Consolidated Edison Company of New York, Inc.
Indian Point Station
Broadway & Bleakley Avenue
Buchanan, NY 10511
Telephone (914) 734-5340
Fax: (914) 734-5718
blinda@coned.com

Re: Indian Point Unit No. 2
Docket No. 50-247
NL 01-092

SUBJECT: Indian Point 2 License Amendment Request for Reactor Coolant System Heatup and Cooldown Limitation Curves and Request for Exemption from the Requirements of 10CFR50.60(a) and Appendix G

Figure 3.1.B-1 Reactor Coolant System Heatup and Leak Test Limitations Applicable for the First 25 EFPY (Without Margins for Instrumentation Errors)

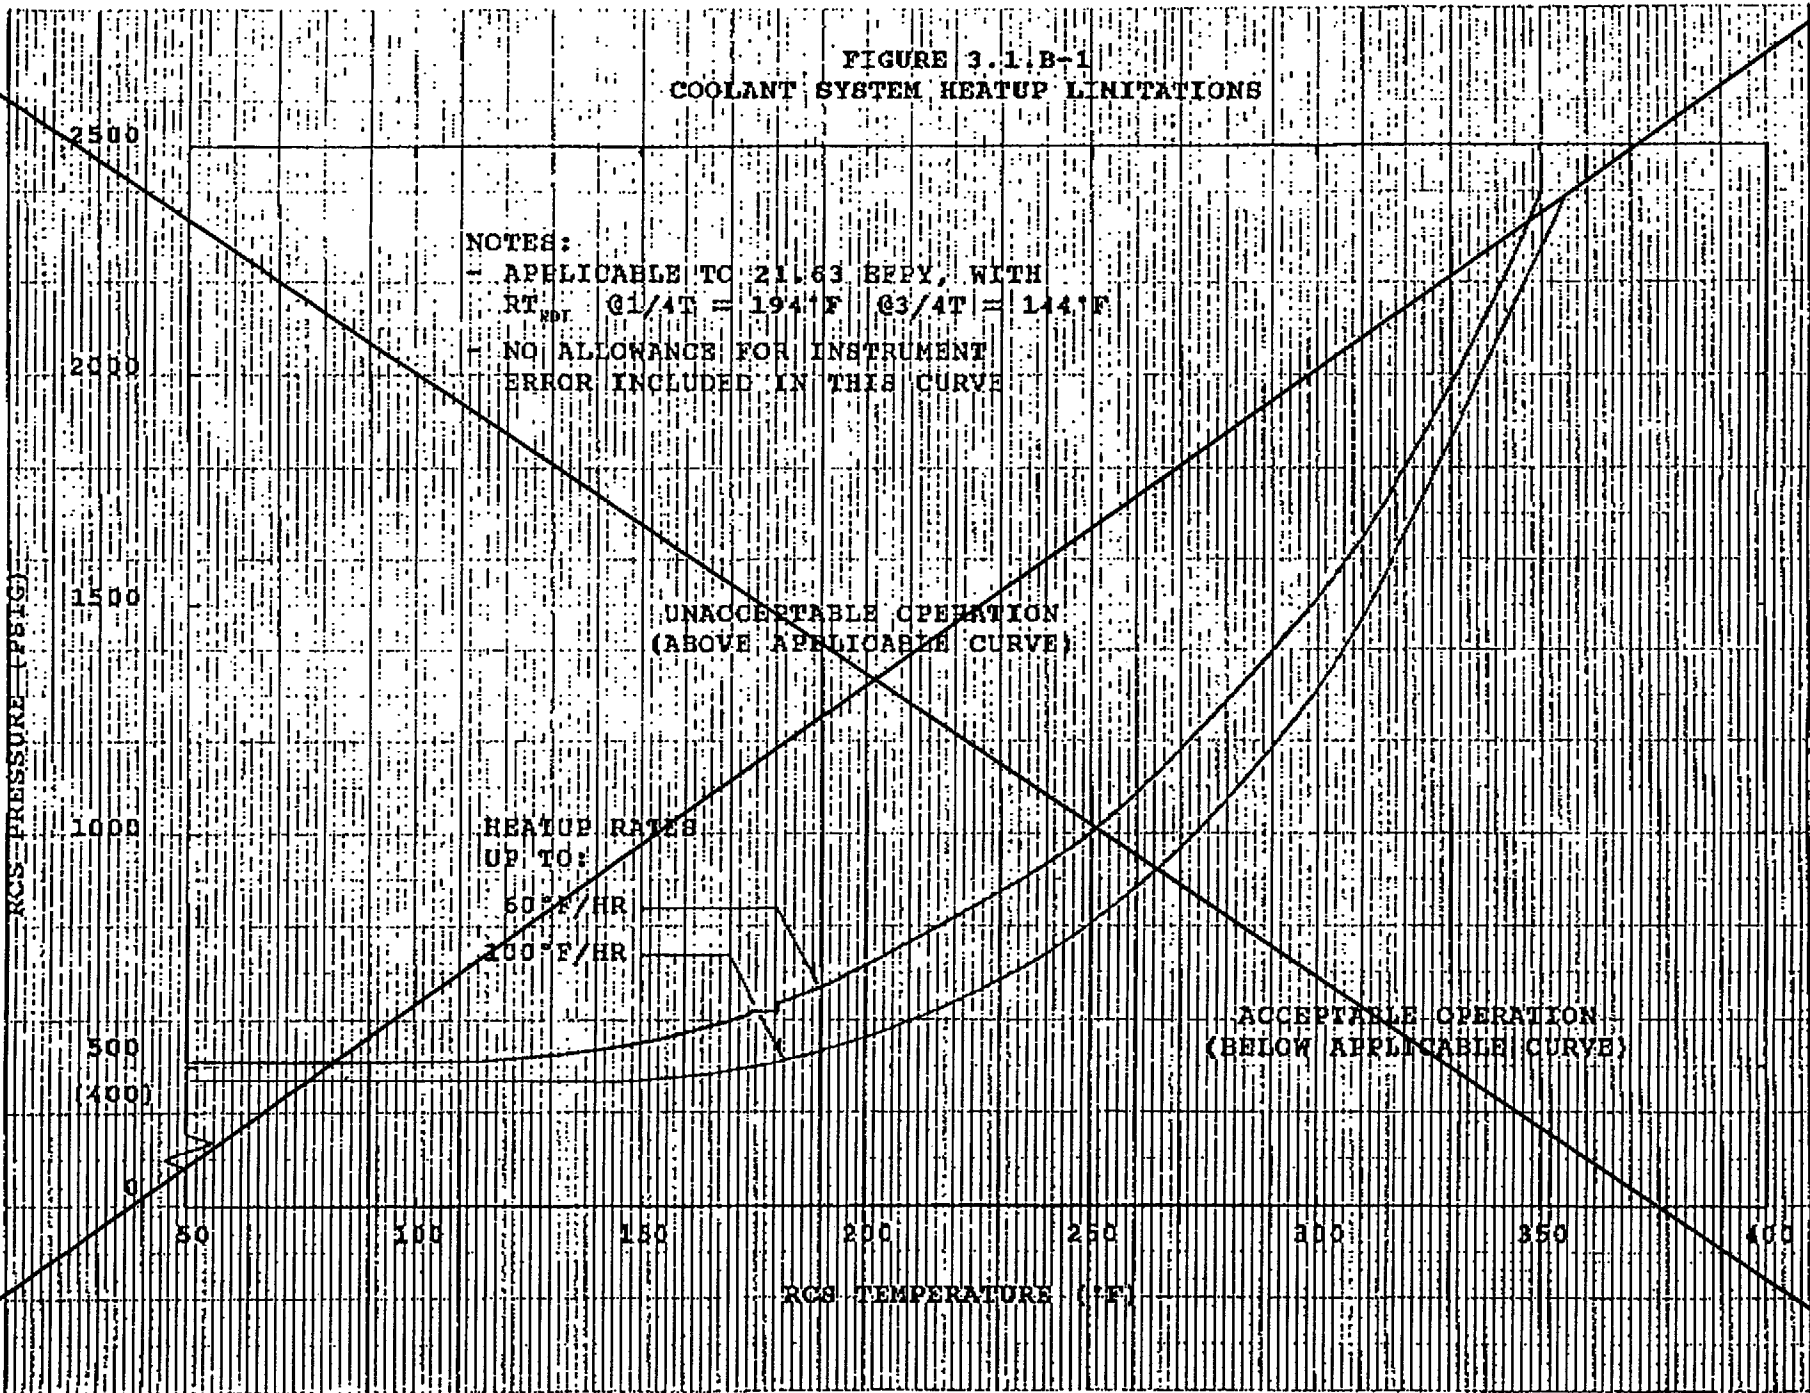
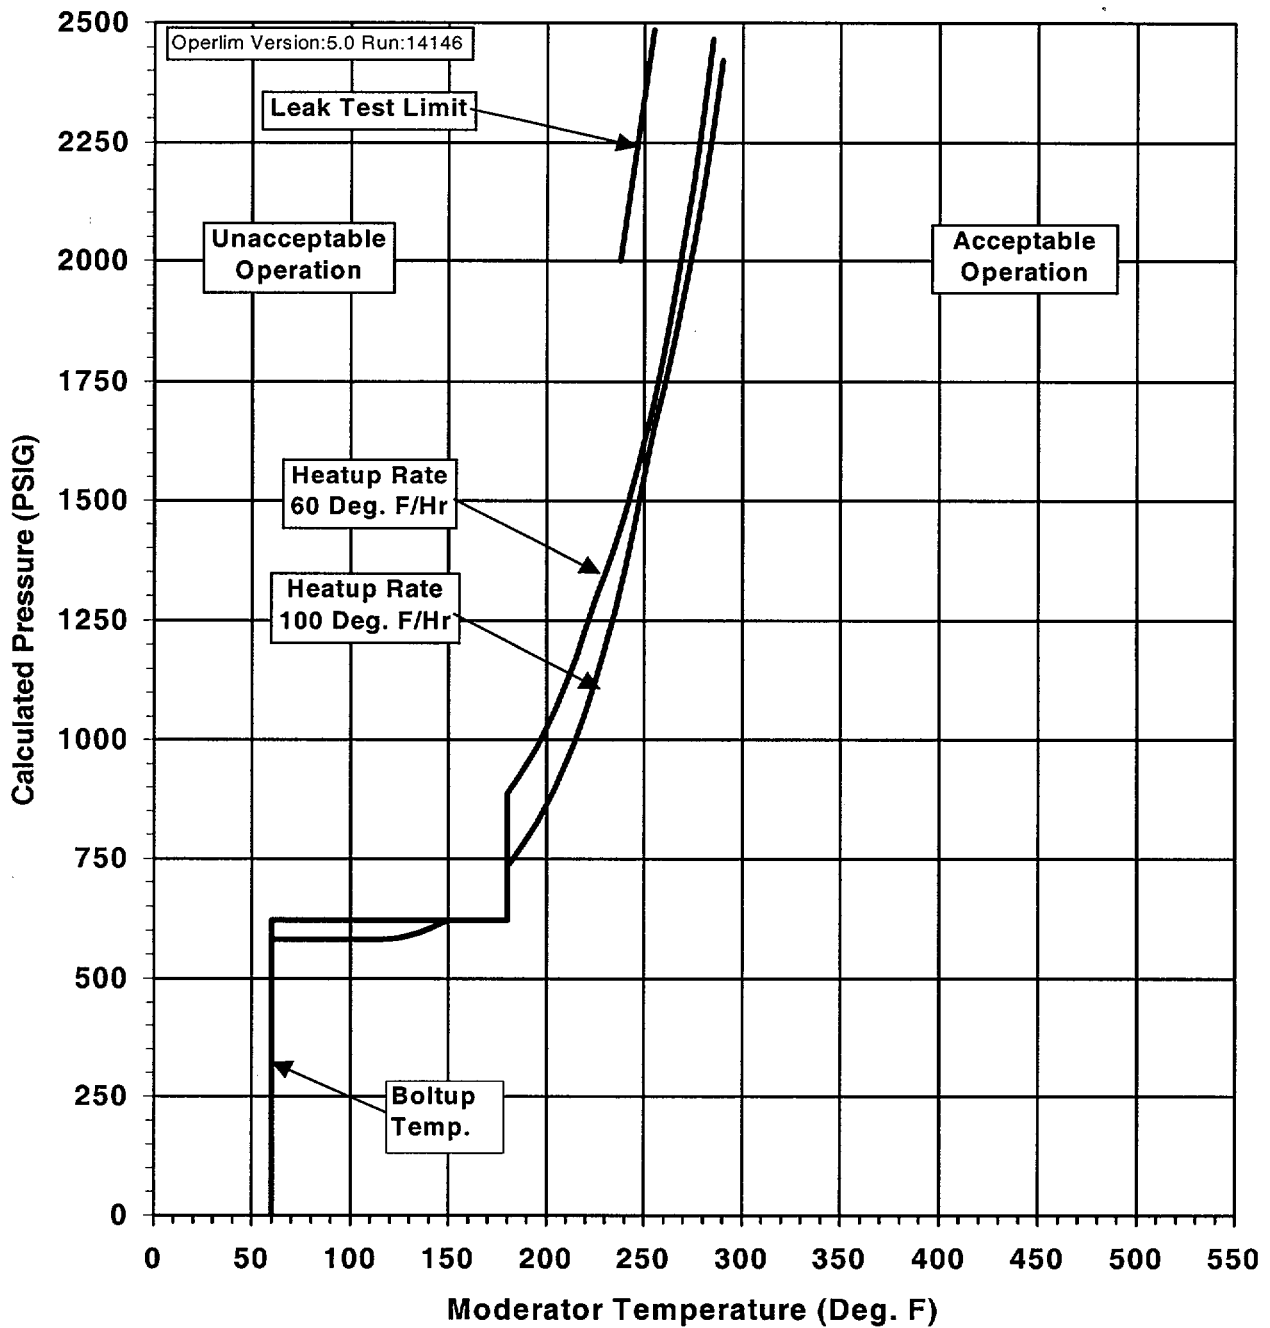
The LAR proposes to delete Figure 4.3-1, "Vessel Leak Test Limitations," and include the vessel leak test limitations in revised Figure 3.1.B-1, "Reactor Coolant System Heatup and Leak Test Limitations Applicable for the First 25 EFPY."

As of April 23, 2001, the IP2 burnup was 17.138 EFPY. The Heatup and Cooldown Limitation Curves that are currently available only allow operation until 18 EFPY. It is anticipated that IP2 will have achieved 18 EFPY by March 3, 2002. These curves require revision prior to the plant reaching the current limit to ensure that continuity is maintained regarding the availability of heatup and cooldown limitations. The revised curves will reflect heatup and cooldown limitations valid until 25 EFPY.

Figure 3.1.B-2 Reactor Coolant System Cooldown Limitations Applicable for the First 25 EFY (Without Margins for Instrumentation Errors)

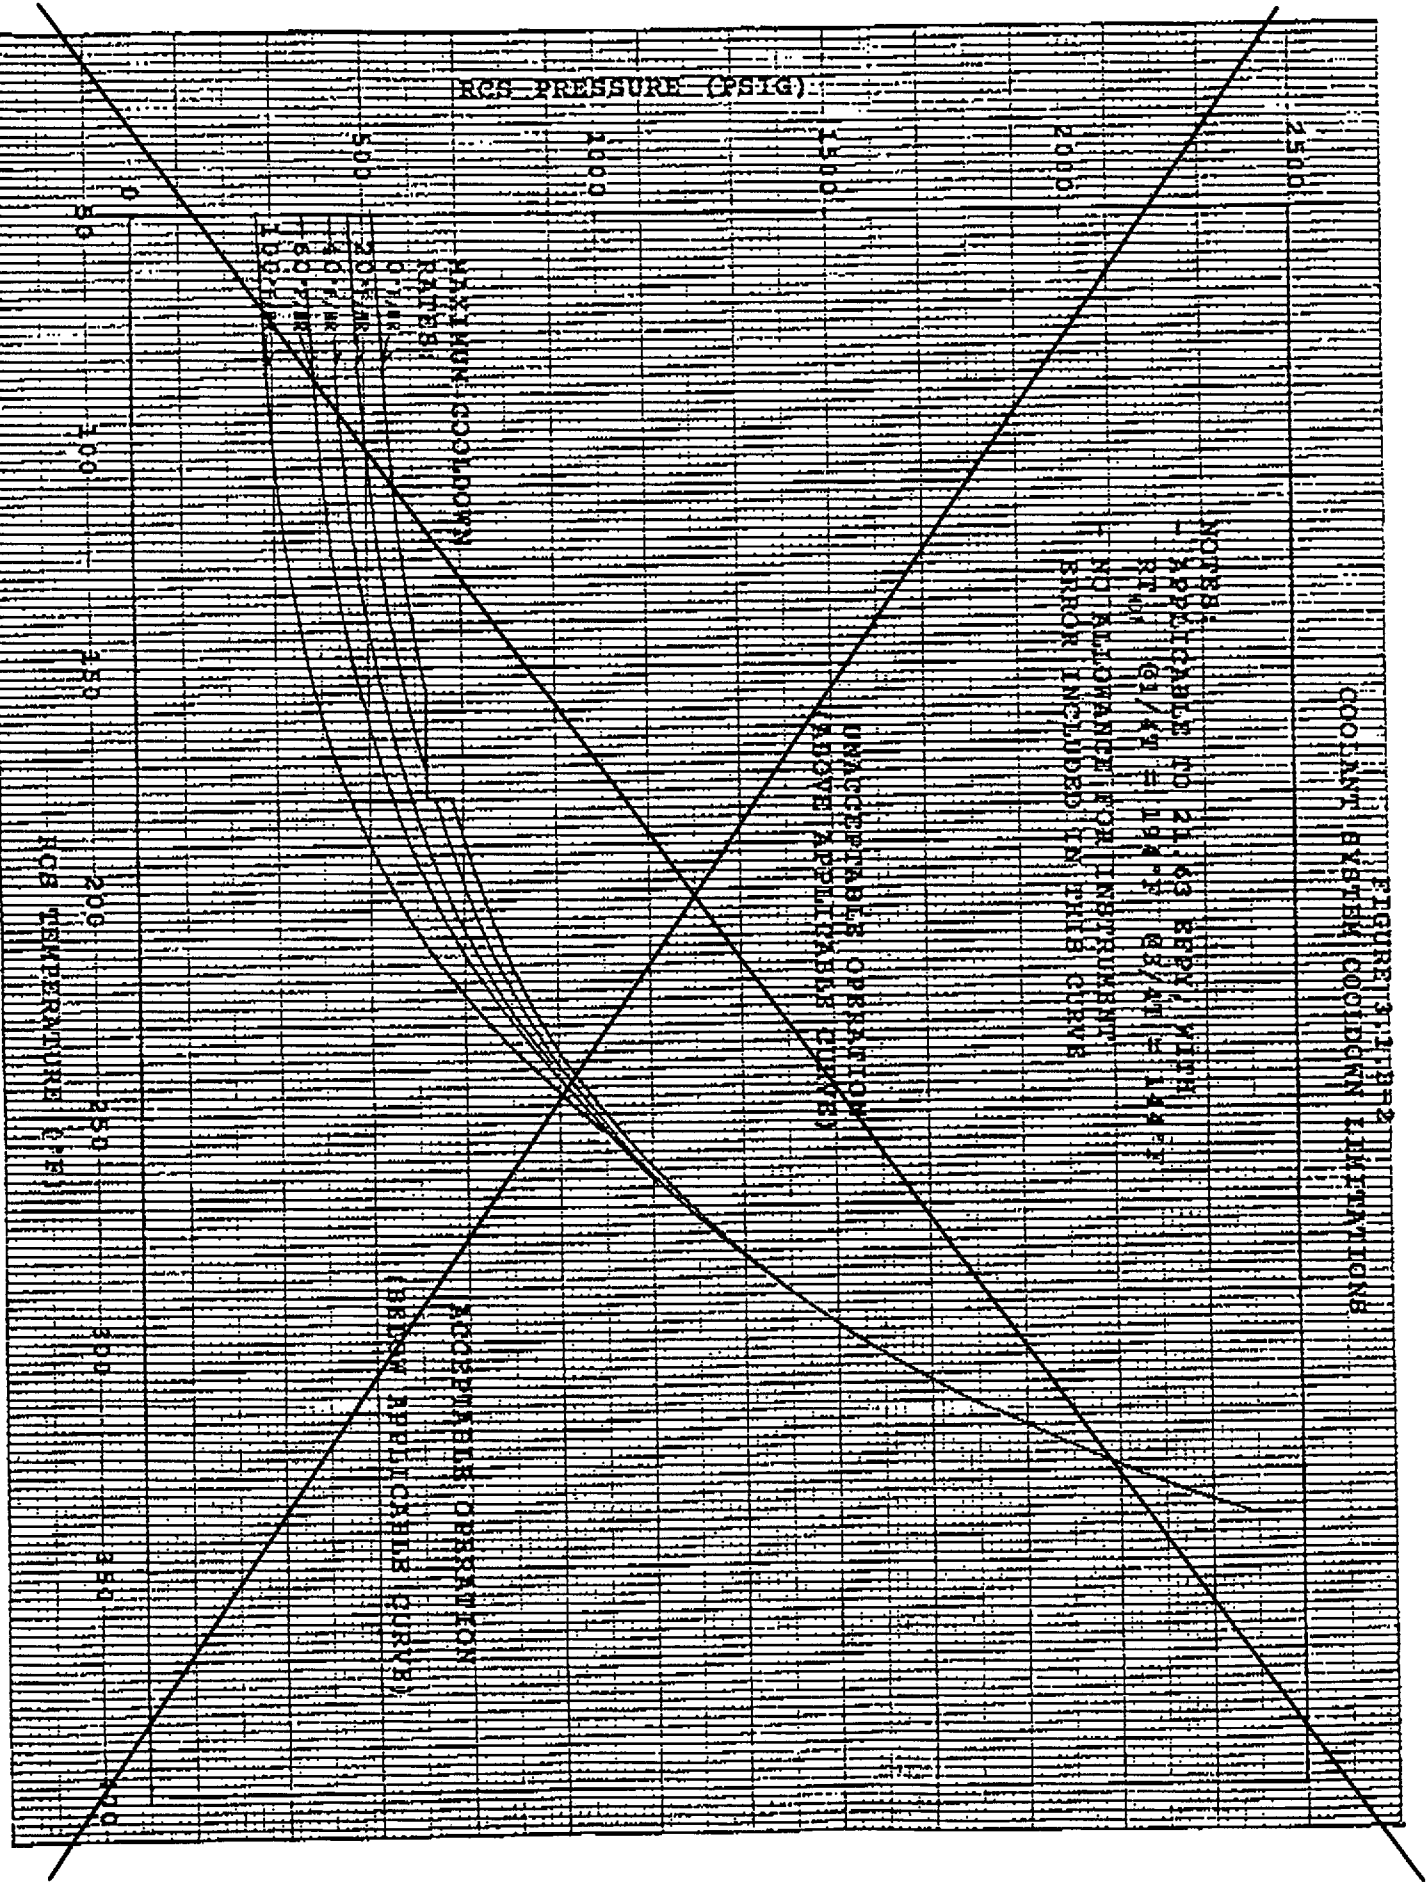
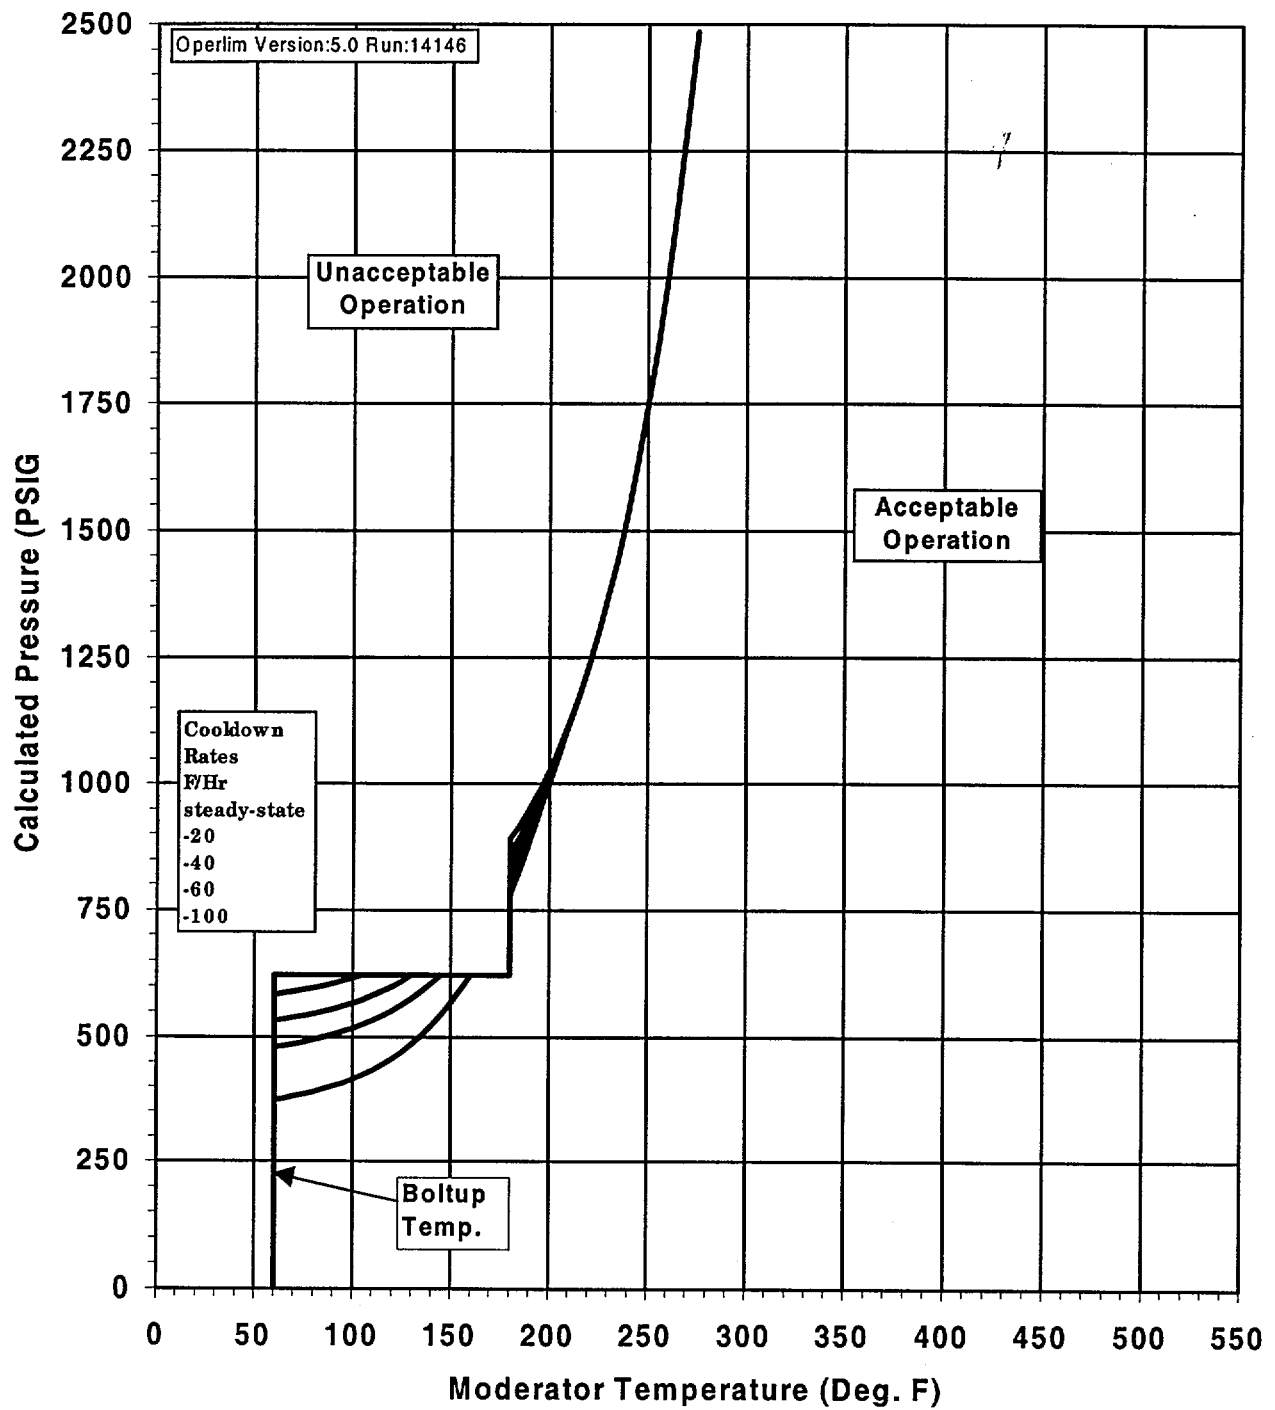
8. Section 3.1.B Reactor Coolant System, Heatup and Cooldown
9. Figure 3.1.B-1 Coolant System Heatup Limitations
10. Figure 3.1.B-2 Coolant System Cooldown Limitations

FIGURE 4.3-1 VESSEL LEAK TEST LIMITATIONS

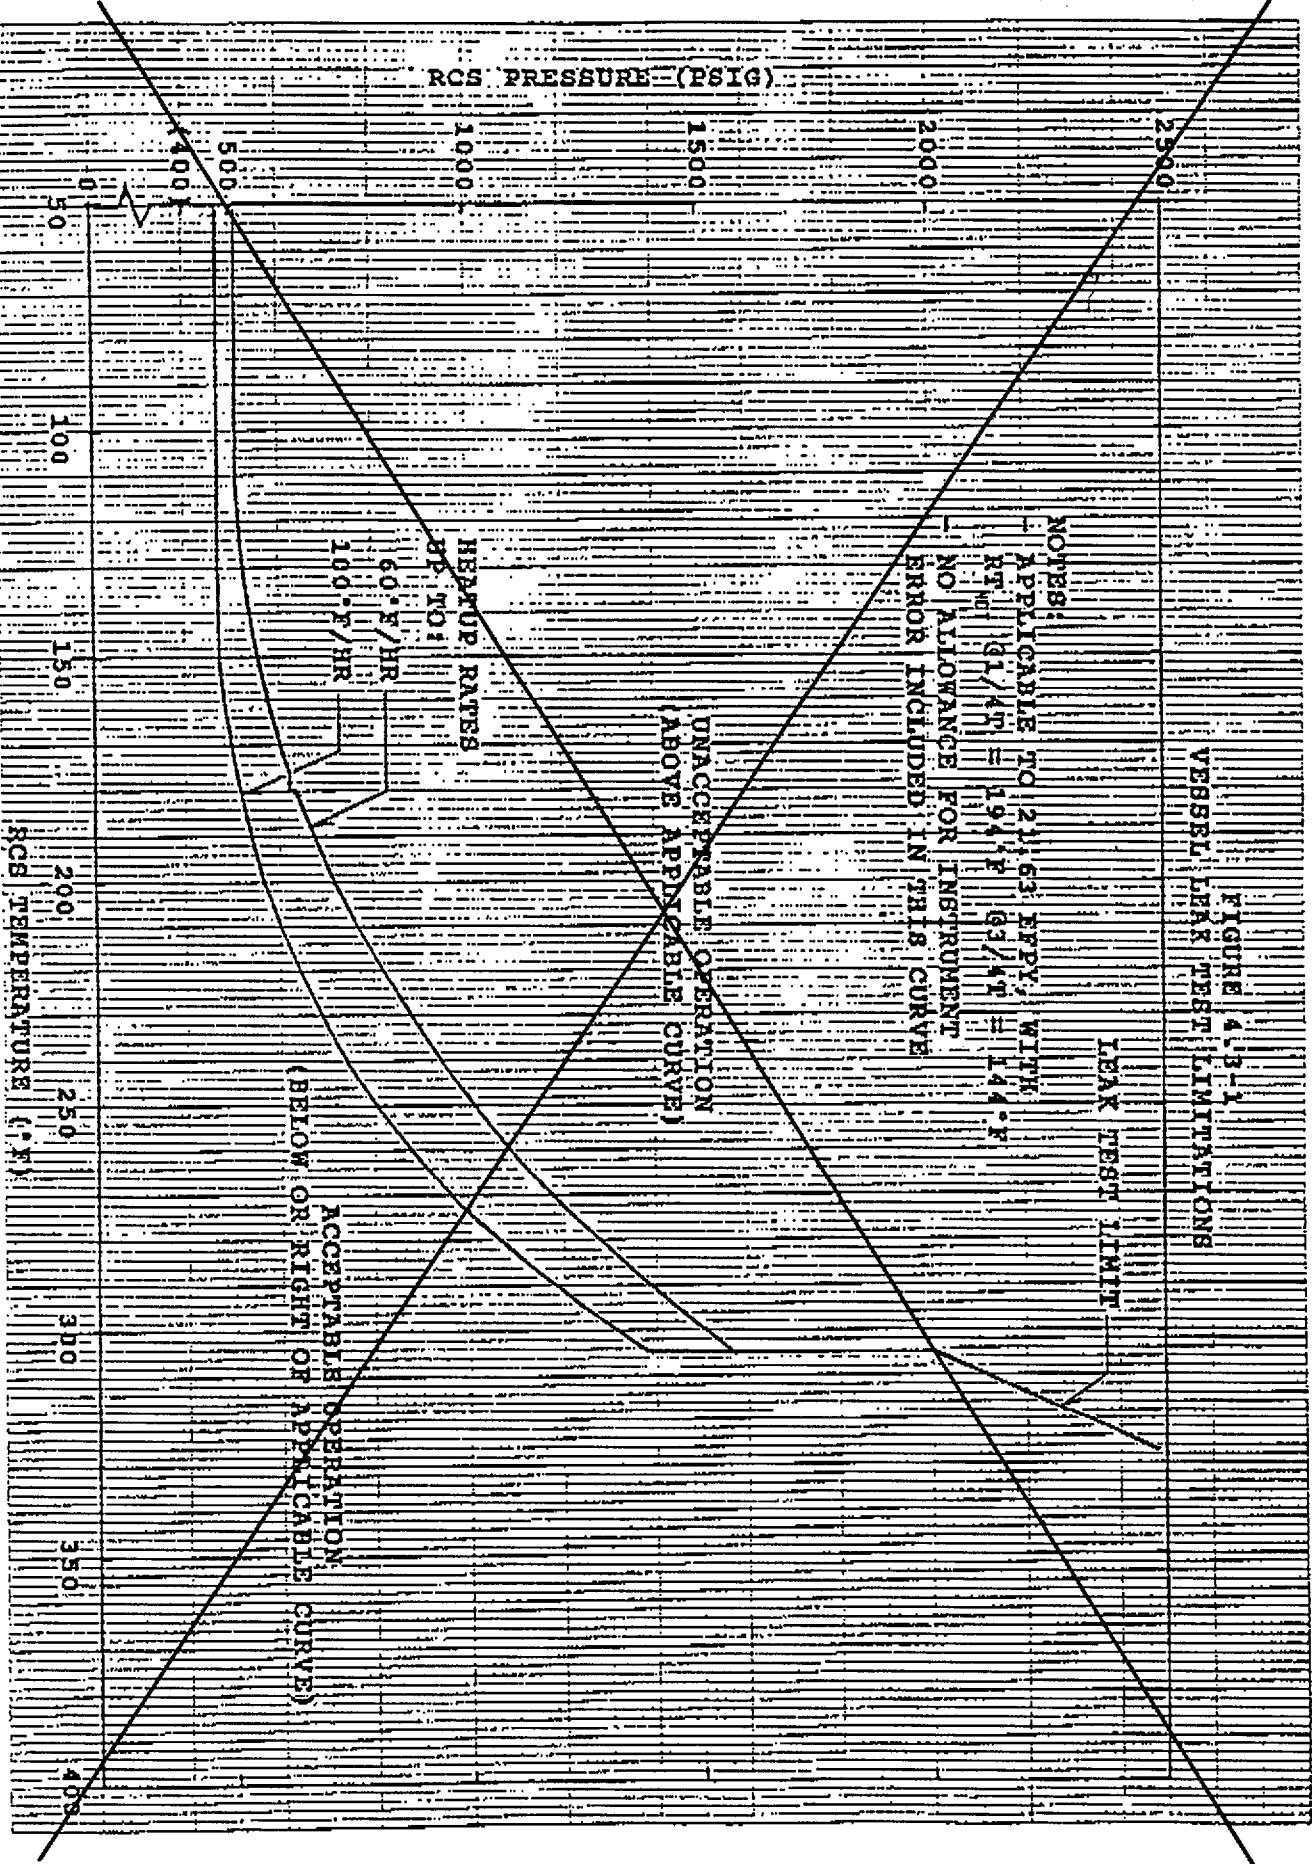
The inservice leak temperatures are shown on Figure 4.3-1 3.1.B-1. The temperatures are calculated in accordance with ASME Code Section III, 1974 Edition, Appendix G and the methods
